CITY OF ALBUQUERQUE

RE: **Lot 27 Block 8 Unit 22 SAD 228**
6624 Sujeto Rd. NW
Volcano Cliffs Subdivision
Grading and Drainage Plan Date: 4/6/2021
Revised Grading and Drainage Plan Date: 8/9/2022
File Number (D10D003K18)

DRAINAGE AND TRANSPORTATION INFORMATION SHEET (REV 6/2018)

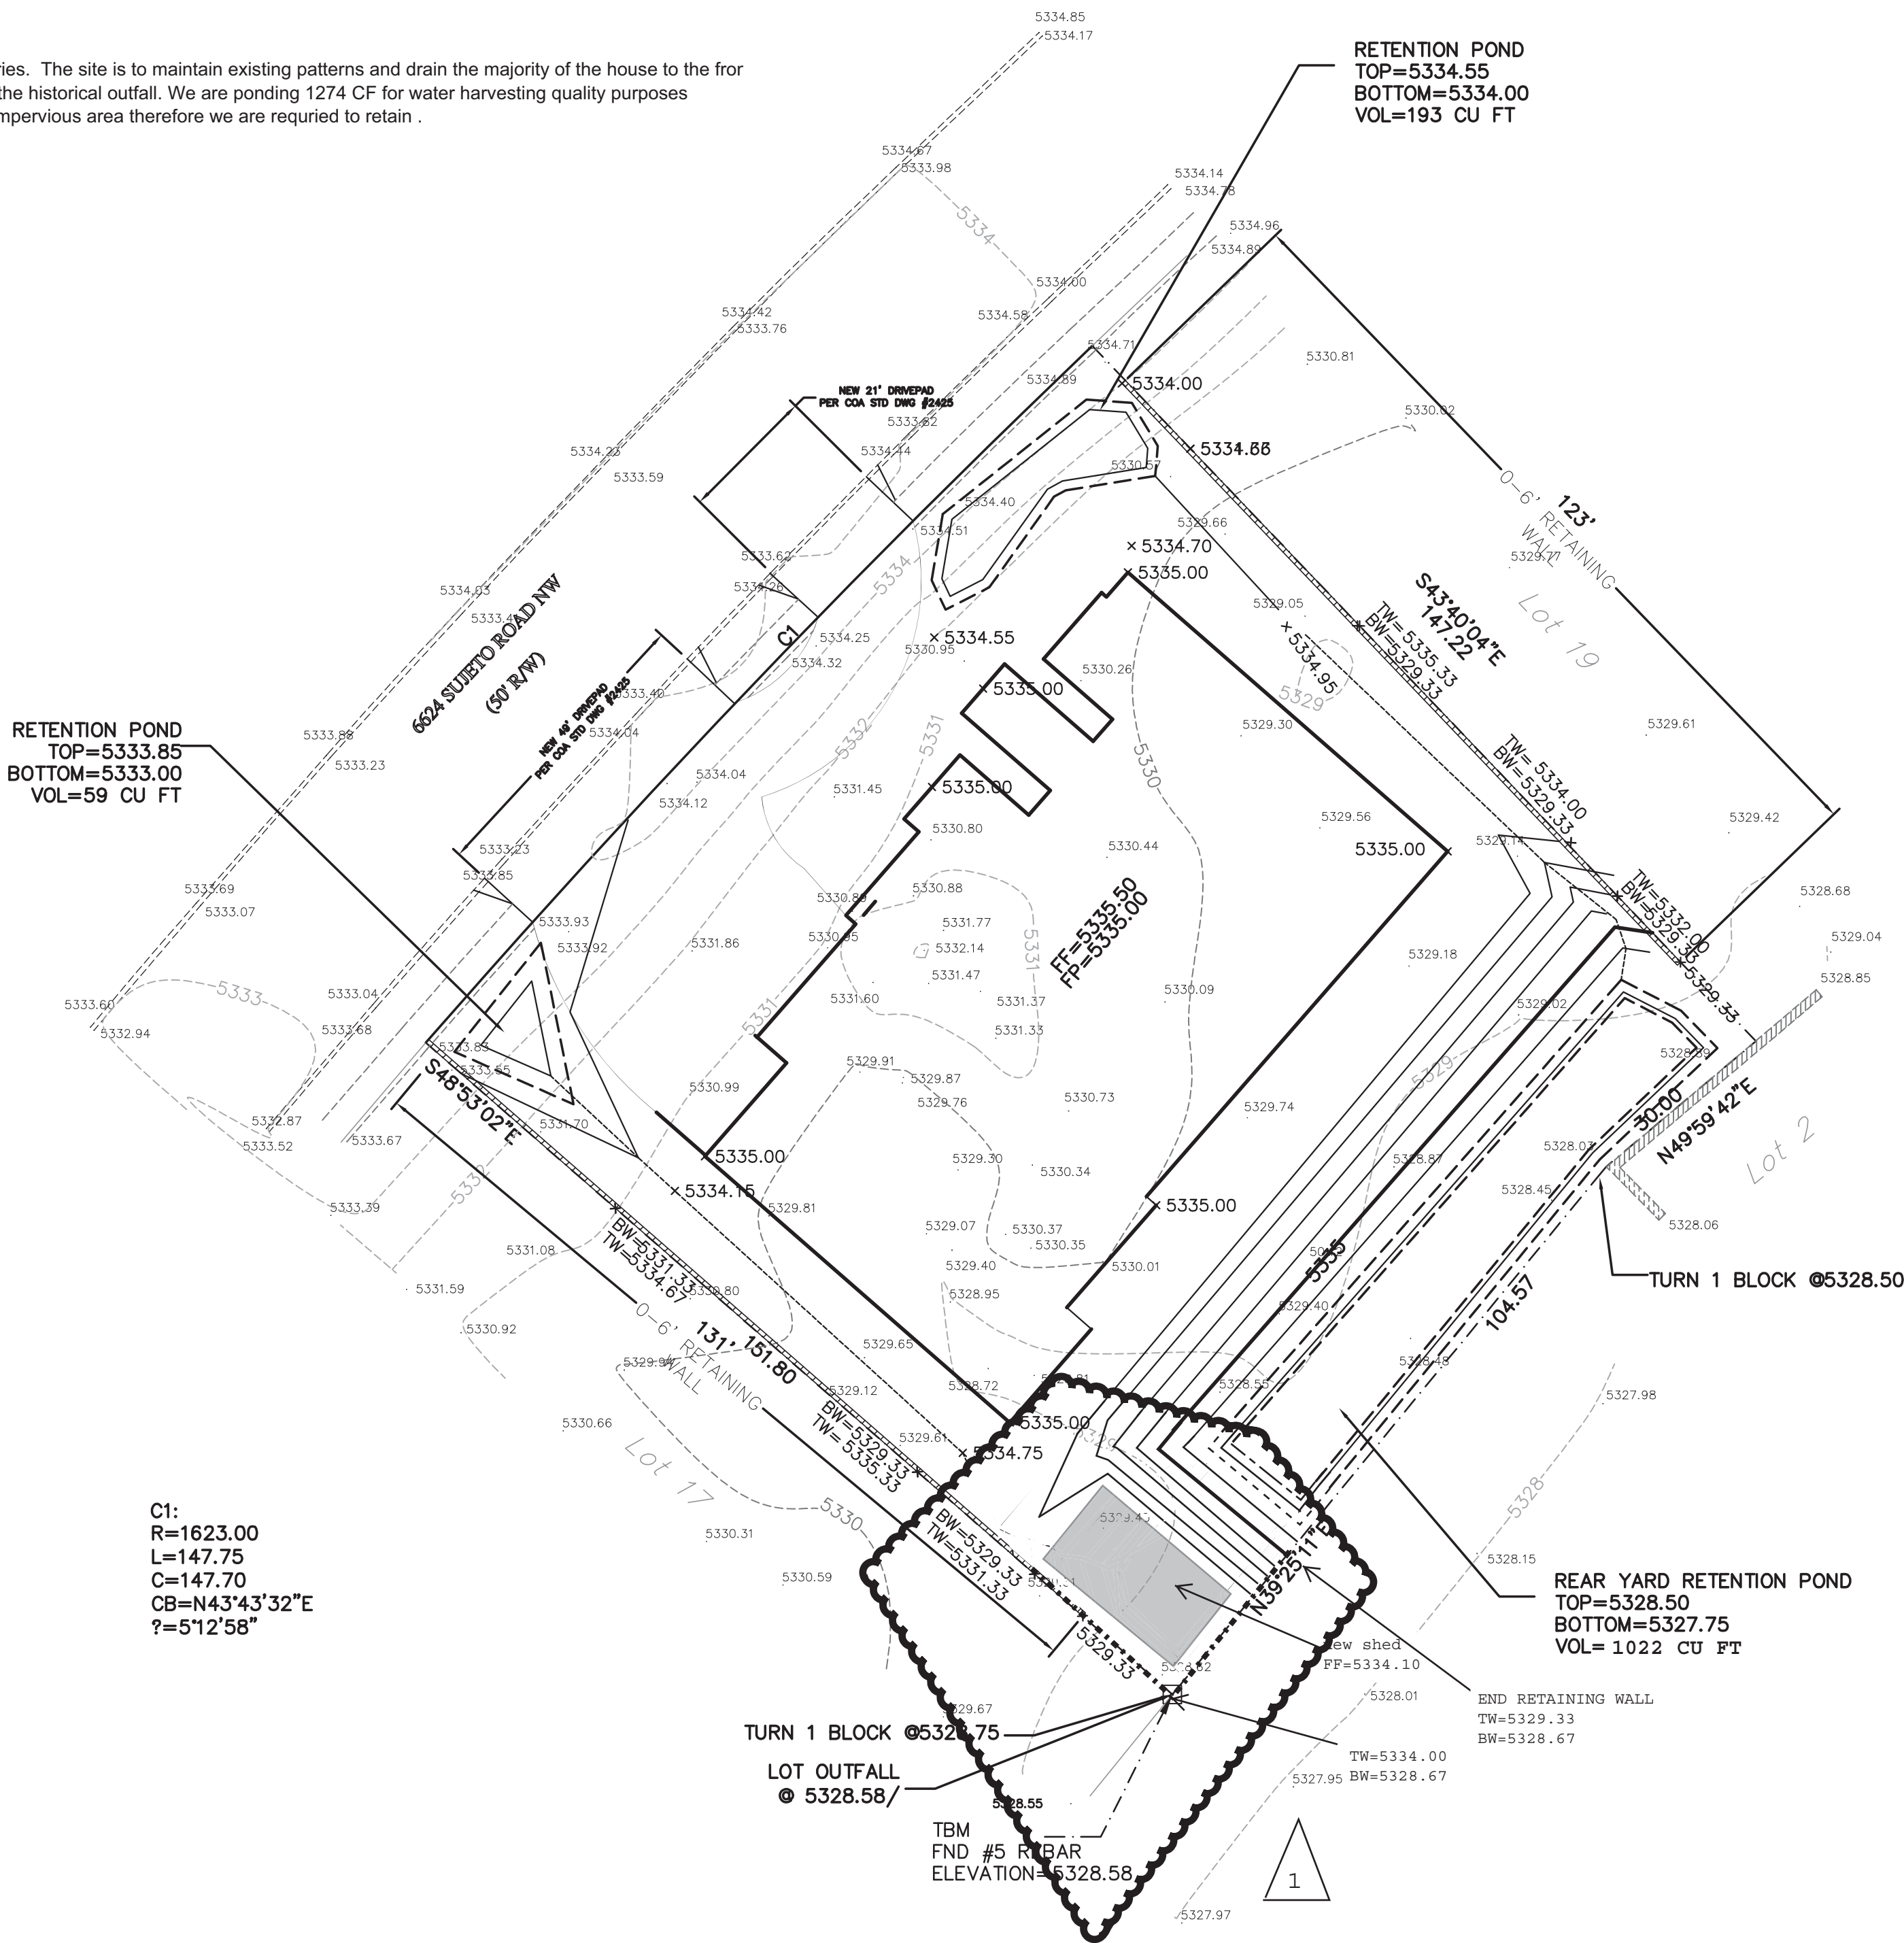
Based upon the information provided in your submittal received 11/14/2022, this plan is approved for Grading Permit and will now be the plan of record.

Prior to Building permit approval a Pad Certification will be required, provided by the Engineer or a registered Land Surveyor.

Advise the owner contractor not to use dirt as a ramp to climb the curb, use lumber or crusher fines for this purpose.

Reiterate to the Owner/Contractor that a separate permit for a garden/retaining wall must be obtained with the approved G&D plan and Pad Certification. Also, if a swimming pool is to be placed the grading and drainage plan will change and will need to be resubmitted.

Prior to Certificate of Occupancy release, Engineer Certification per the DPM checklist is required.
